GPU NUCLEAR CORPORATION
SAXTON NUCLEAR EXPERIMENTAL CORPORATION
APPENDIX A: TECHNICAL SPECIFICATIONS TO
AMENDED FACILITY LICENSE NO. DPR-4

ATTACHMENT G
EXPLANATION OF APPENDIX A REVISION
PAGES 1 TO 4

ATTACHMENT G
EXPLANATION OF APPENDIX A REVISION

Figure 2

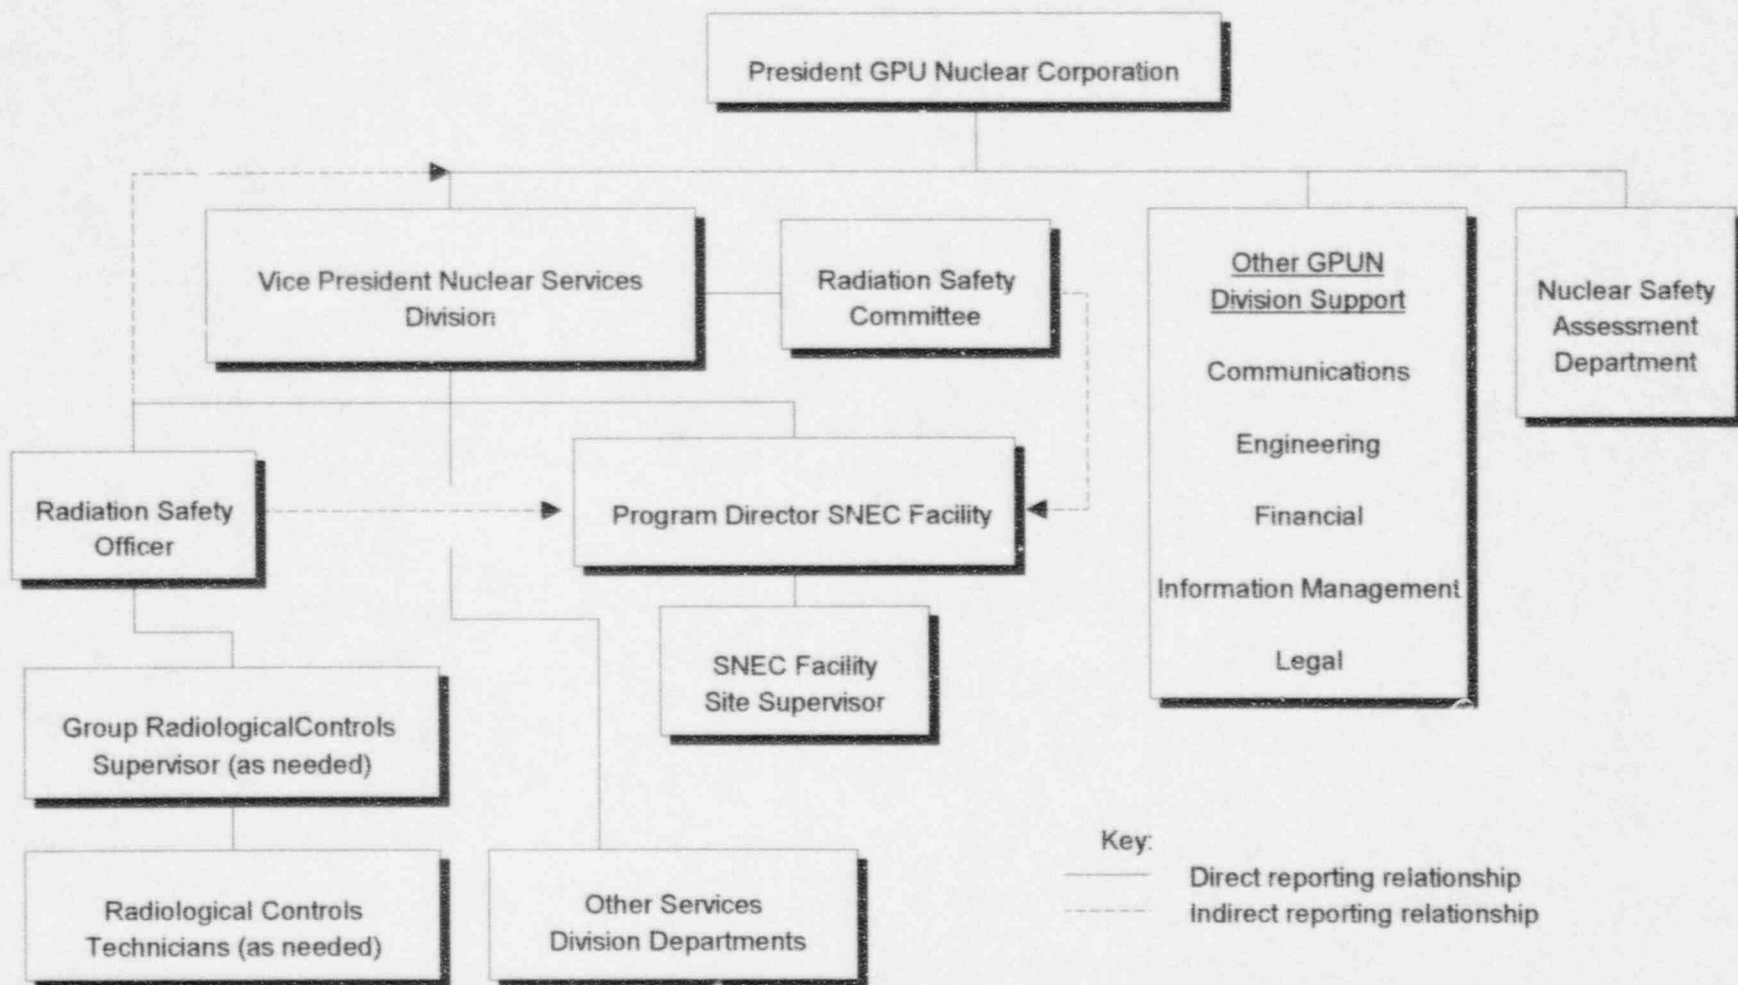
Figure 2 changes:

1. With the transfer of management responsibilities to GPU Nuclear, the SNEC Board of Directors and President SNEC are eliminated from the organization chart.

2. The Vice President NSD is included in the organization chart since the Program Director SNEC Facility reports directly to the position. Various NSD departments provide services in support of Saxton facility activities. They are direct reports and are indicated in a new box, titled "Other Services Division Departments". Note that these departments (Environmental, Human Resources, Regulatory Affairs and Training) are not specifically identified. They are intentionally omitted to preclude the need for additional Technical Specification changes based on a position name change or reporting change within the Division.

3. The Radiation Safety Committee reports directly to the Vice President NSD and maintains an indirect reporting relationship with the Program Director SNEC Facility, encouraging communication between the Committee and site management.

4. The Radiation Safety Officer reports directly to the Vice President NSD and is tied via an indirect reporting relationship to both the President GPU Nuclear and the Program Director SNEC Facility to encourage communication among the positions.

5. The box previously labeled Technical Support identified GPU Nuclear departments and depicted them as reporting directly to the President GPU Nuclear. They in fact are departments of other GPU Nuclear divisions (besides NSD) which in turn report directly to the President GPU Nuclear and provide activities in support of the Saxton facility. The box has been renamed Other GPU Nuclear Division Support to more correctly identify the relationship.
